Householder Proforma

Application Ref: 2021/0645
Address: 152 Barugh Lane, Barugh Green, Barnsley, S75 1LL
Development Proposal: Extension of roof height, provision of front and rear facing dormers and alterations to the external facing materials.

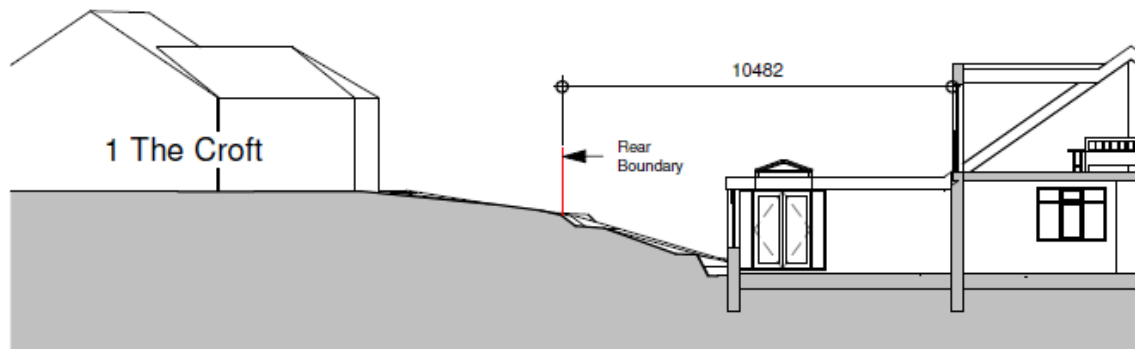
The dwelling has a large curtilage that sets it significantly away from all adjacent boundaries. The closest boundary, the western boundary shared with 1 and 3 The Croft, is set up hill with the curtilages' of those properties set even further uphill (>2m). The result is that, despite the increase in roof height by 0.6m and the creation of a wider roof ridge, it is not considered that the impact of the vertical aspect of the extension shall create an unreasonable level of overshadowing or overbearance given the distance of the applicant's bungalow to the western boundary combined with the increase in gradient beyond that boundary.

The overshadowing caused by the dormers on both roof slopes is determined to be negligible given that they will mostly be within the shadow of the main ridge and the gable ends throughout the day.

Section 1 - 1 The Croft

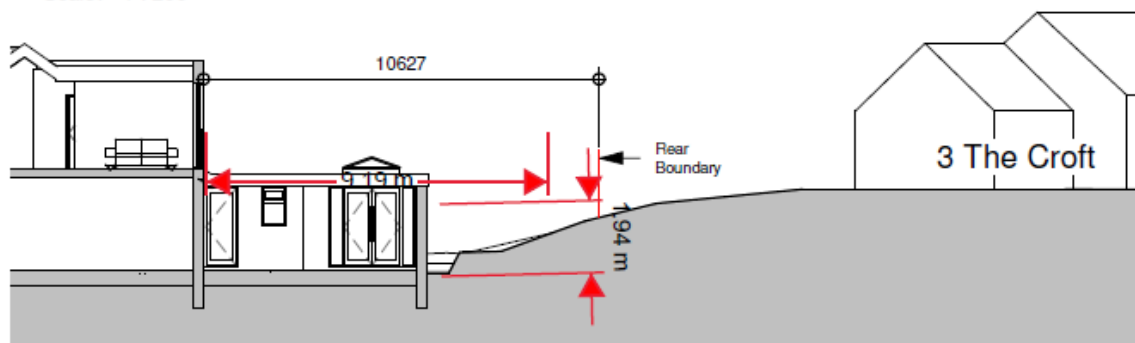
Regardless of the above arrangement in respect of the ownership boundary, the assessment that is considered more appropriate in this instance is the distance to the boundary treatment which separates the applicant's property from their neighbours further west and the interaction of the outlook from the new first floor windows relative to the private curtilages opposite. In this aspect, the distance is 9.2m between the new windows and the fencing and this is below the 10m minimum required by the SPD. That being said, the increase in gradient to the west more than offsets the impact of the separation distance between the windows in the rear dormer and the western fence as evidenced in the section plan below:

Indeed the above evidences that the fall of the land creates an equal relationship between the windows on the rear elevations of the dwellings on The Croft and the applicant's property. Meanwhile the Juliette balcony of the dormer where the habitable room is located faces the shared boundary between 1 and 3 The Croft. This relationship significantly lessens the impact of the level of overlooking of private space that is incurred as the areas near the boundary. This is not to say that no privacy loss will be incurred, particularly for 3 The Croft, however the level of privacy loss is determined to be within acceptable levels given that the shortfall of the rear first floor window relative to the western boundary is small (approx. 0.8m) and the increase in topography to the west more than offsets the level of overlooking.

At request of the case officer, the rear window of the balcony was amended to include a glass balustrade to form a Juliette balcony. This is to prevent use of the single storey rear extension's roof as a terrace, which would incur more significant harm, to surrounding residents. The balustrade will be conditioned to remain in situ unless otherwise agreed in writing with the LPA.

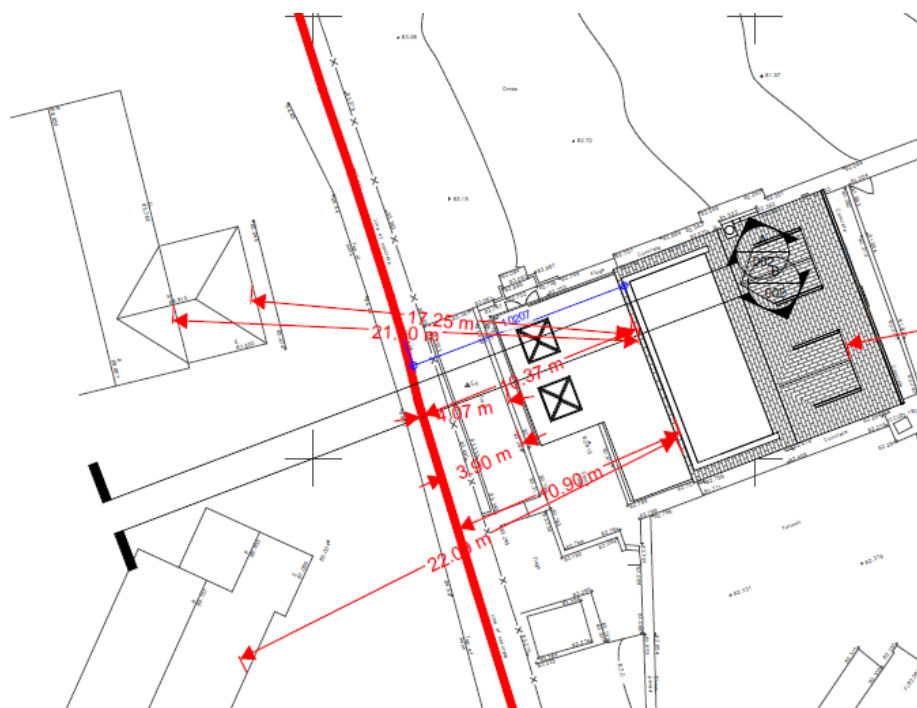
It is acknowledged that the separation distance from the habitable room window within the dormer would be positioned less than 21m spacing standard between habitable rooms that face one another set out within the SPD Design of Housing Development to the nearest part of the extension that is part of No.1 The Croft. However, I am content that the new main habitable window would primarily be orientated to face side elevation of 3 The Croft, as presented in the site plan below and 21m is achieved to the original rear wall. In addition No.1 the Croft is on a higher land level as evidenced by the cross section and so the ability to look down and sideways would be largely mitigated against by existing boundary treatments:-

22m would be achieved to the rear of no.3 The Croft with the window on the right hand side of the dormer serving a bathroom and likely to be fitted with obscure glazing in any case.
